SP13-42: INTERFERENCE BETWEEN CEILING AND GAS SPRING ON SOME LUGGAGE DOORS
REFER TO SAP FOR CODES AND VEHICLES
VEUILLEZ VOUS RÉFÉRER AU RETROFIT R13043 POUR LA VERSION FRANCAISE

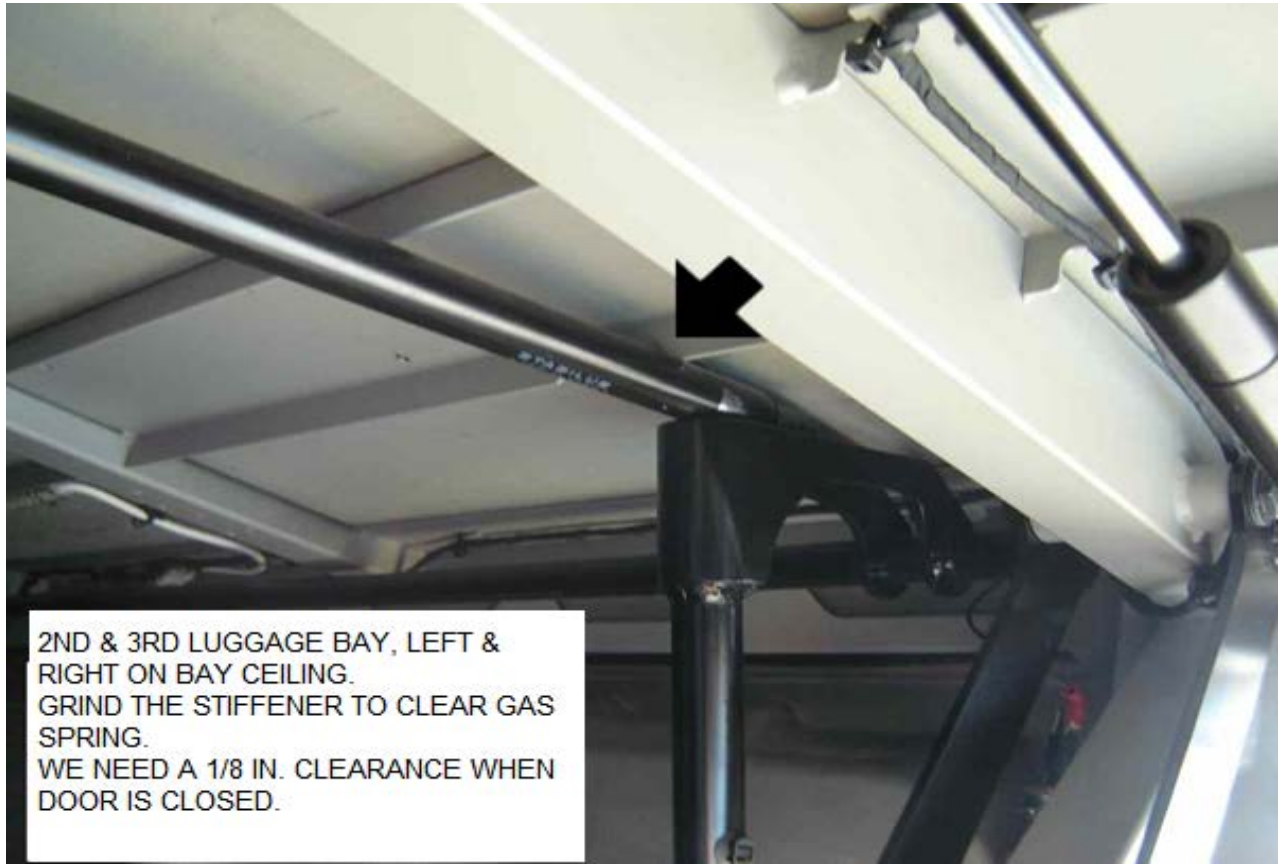
POSSIBLE INTERFERENCE BETWEEN STIFFENER FOR WCL RAIL WHEN LUGGAGE DOOR IS CLOSED.

INSPECT EACH GAS CYLINDER TO MAKE SURE THERE IS NO INTERFERENCE WITH THE PASSENGER'S FLOOR STIFFENERS WHEN LUGGAGE DOOR IS CLOSED.

FIRST MAKE SURE THAT THE CYLINDER IS INSTALLED IN THE RIGHT ORIENTATION: ROD END ON VEHICLE STRUCTURE, BODY (LARGE END) ATTACHED TO DOOR ARM.

INSPECT GAS SPRING TO MAKE SURE IT HAS NOT BEEN BENT BY PREVIOUS DOOR OPERATION IF THIS IS THE CASE, REPLACE BY 930030

IF THERE IS INTERFERENCE, GRIND THE STIFFENER TO GET A CLEARANCE OF 1/8 IN. MINIMUM WITH CYLINDER.

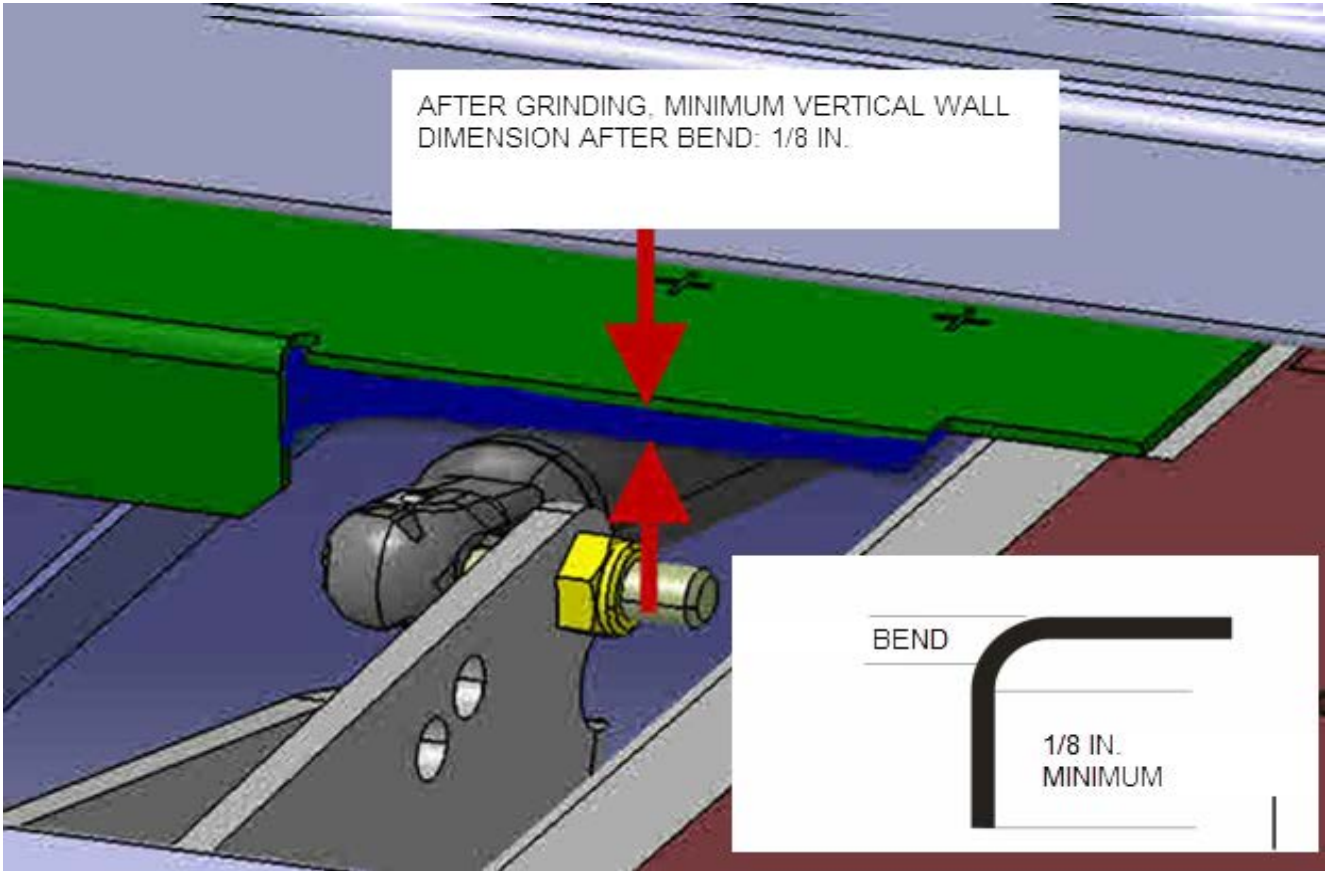
THERE MUST REMAIN AT LEAST A 1/8IN (3MM) BEND ON THE STIFFENER AFTER GRINDING ELSE INFORM MAURICE GAGNÉ'S SERVICE TEAM BY PROVIDING DOOR POSITION AND VEHICLE NUMBER.

AFTER GRINDING, MINIMUM VERTICAL WALL
DIMENSION AFTER BEND: 1/8 IN.

1/8 IN.
MINIMUM
